157 DC - _____ Duncan Creek Rd., Lillington, NC 27546

The Guilford Georgian - RH

10-21-24 - Redlines - JJ
 11-11-24 - added revised structural sheets - JJ

DRAWN BY:
New Home Inc. - Jennifer Jones
ISSUE DATE:
07-25-2023
CURRENT REVISION DATE:
SCALE:
1/8" = 1'-0"
SHEET
2.0

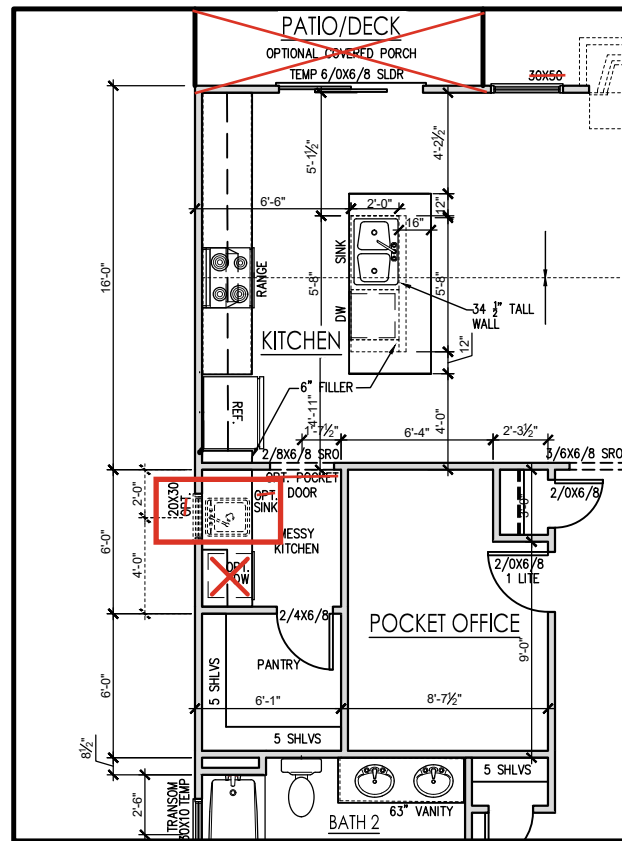
2.1 - messy kitchen, pantry, kitchen

SHEET
3.1.1

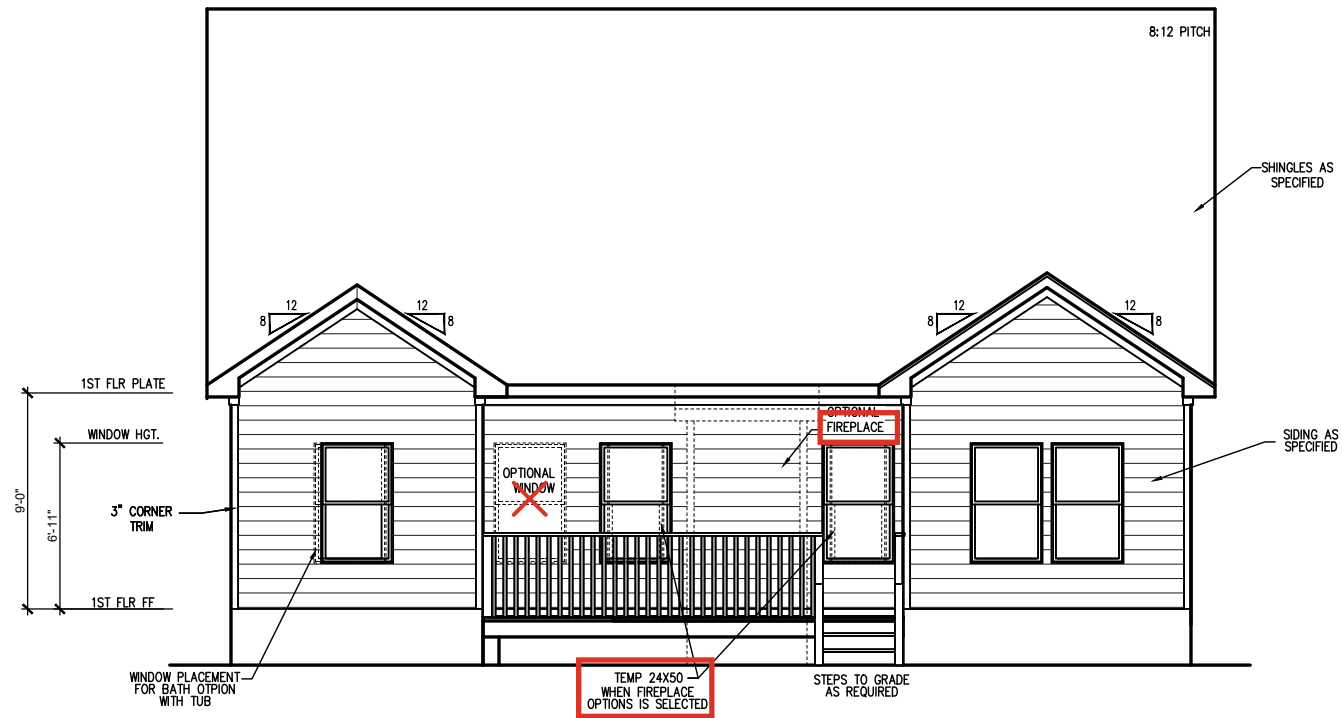
3.3.1- side of ext. cafe
